**STAFF REPORT
ACTION REQUIRED**

**Application for Encroachment Agreement
95 Prescott Avenue**

Date:	May 11, 2007
To:	Etobicoke York Community Council
From:	Curtis Sealock, District Manager, Municipal Licensing and Standards
Wards:	Ward 17, Davenport
Reference Number:	Folder Number 07 112149 RAW 00 IR

Attachment 2: Site Plan

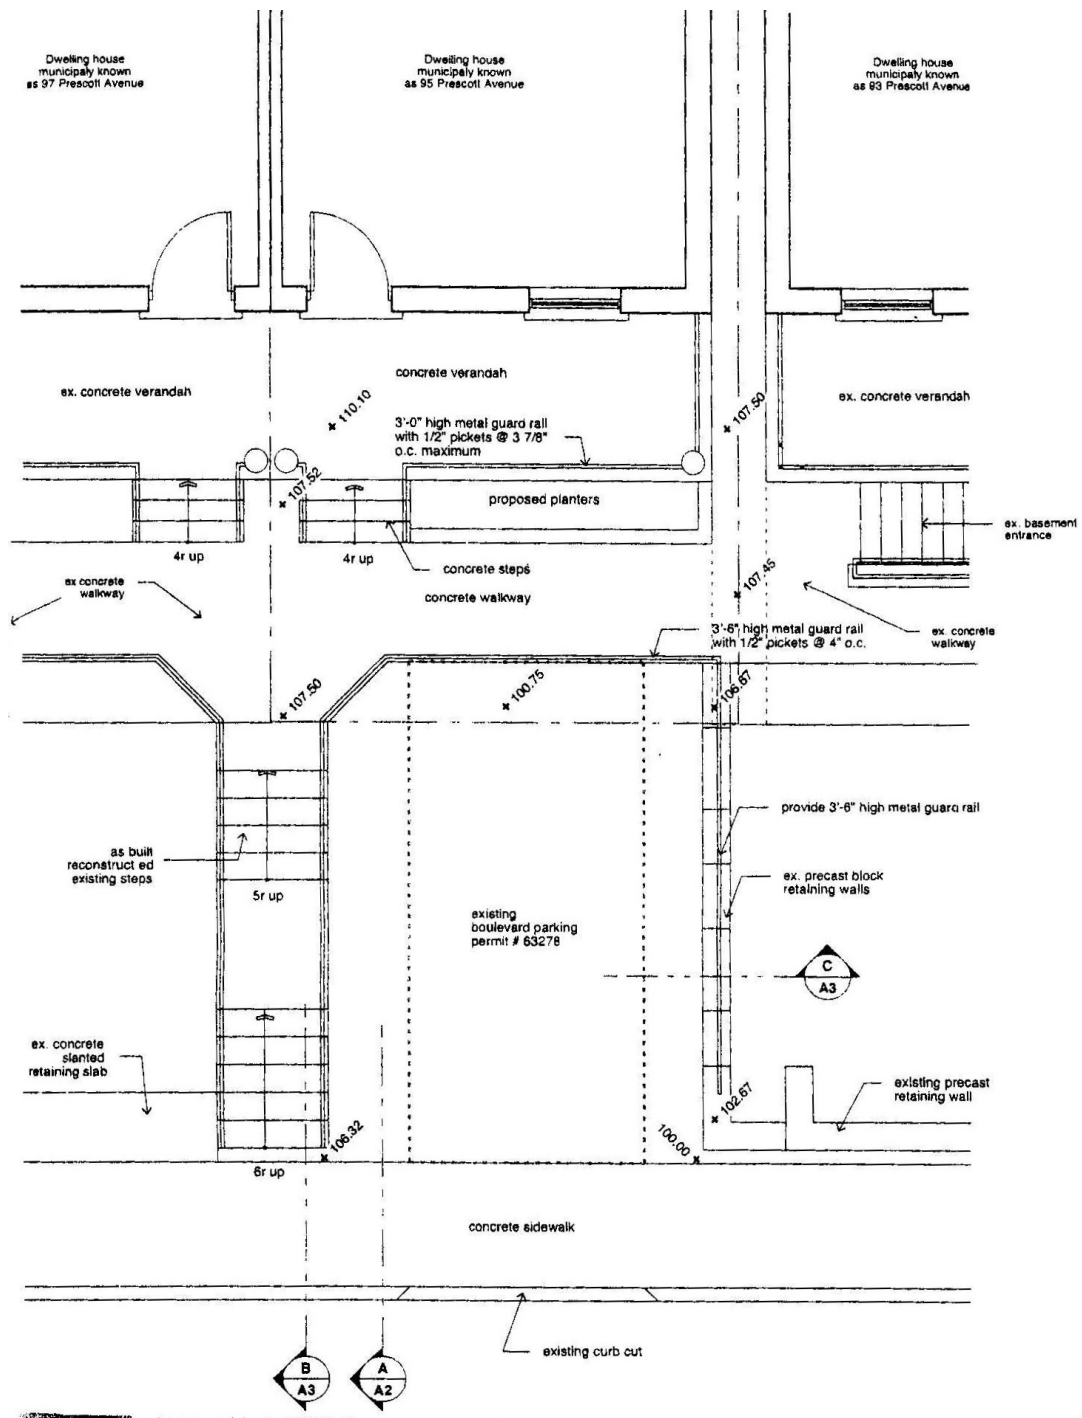
A concrete block retaining wall has been built alongside the south property line to make space for parking of a vehicle which is subject to a Front Yard Parking Permit Number 63278 (Attachments 2 and 3).
